Bay Area Branch
690 Walnut Ave. St. 150
Vallejo, CA 94592-1133
(707) 649-5453
(707) 649-5493

Contract #: 04-0120F4Cty: SF/ALA Rte: 80 PM: 13.2/13.9File #: 1.28**WELDING INSPECTION REPORT**

Report No: WIR-026524
Date Inspected: 14-Oct-2011

Project Name: SAS Superstructure
Prime Contractor: American Bridge/Fluor Enterprises, a JV
Contractor: American Bridge/Fluor Enterprises, a JV

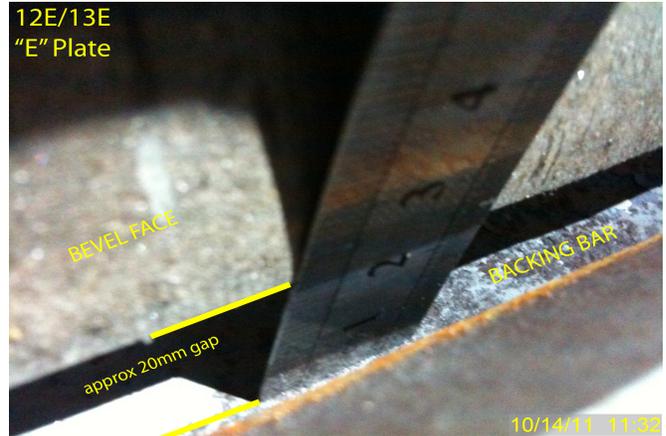
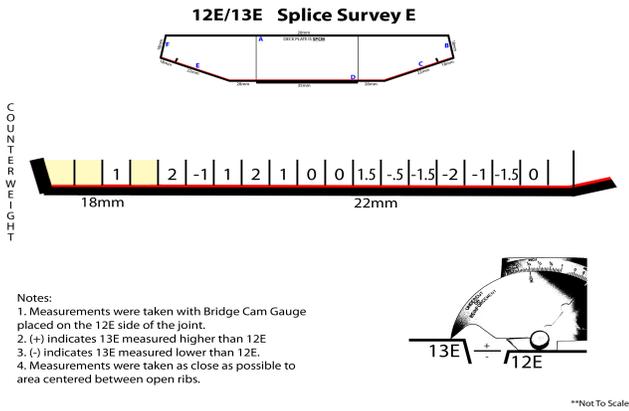
Approximately 11:00 QA observed the joint fit-up for connection 12E/13E “E” side plate. QA noted that the backing bar from approximately (Y=1524mm ~ 3657mm) was not within 2mm of base material. The gap between the backing bar and the base material measured from (15mm ~ 25mm) at various locations throughout aforementioned Y locations.

Please see attached photograph for visual representation.
